World Forum for Harmonization of Vehicle Regulations

Regulations Nos. 13 and 13-H (Braking)

Proposal for amendments to Regulation No. 13 (Heavy vehicle braking) and 13-H (Brakes of M₁ and N₁ vehicles)

Submitted by the experts from Germany and The Netherlands*

Annex 14 - Appendix

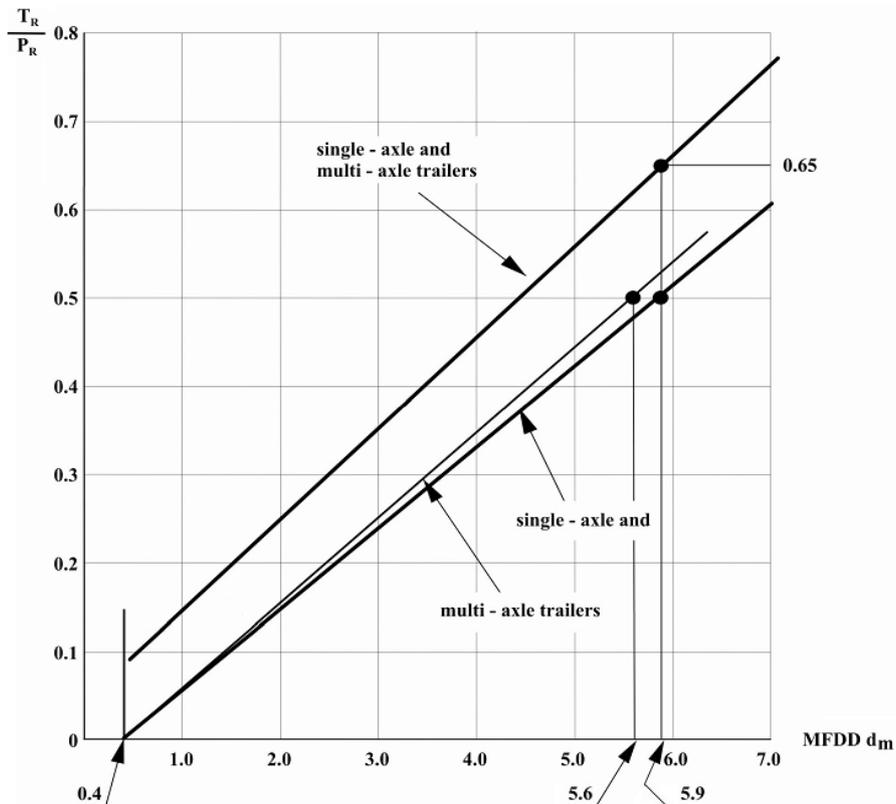
In the diagram the terms "centre-axle trailer" and "semi-trailer" shall be used in stead of "single-axle trailer". The term "full trailer" shall be used in stead of "multi-axle trailer".

32. Terms "single axle trailer" and "multi-axle trailer" changed for clarity, in the past terms such terms were used. In the meantime these terms are no longer current and replaced by "full trailer", "centre-axle trailer" and "semi-trailer".
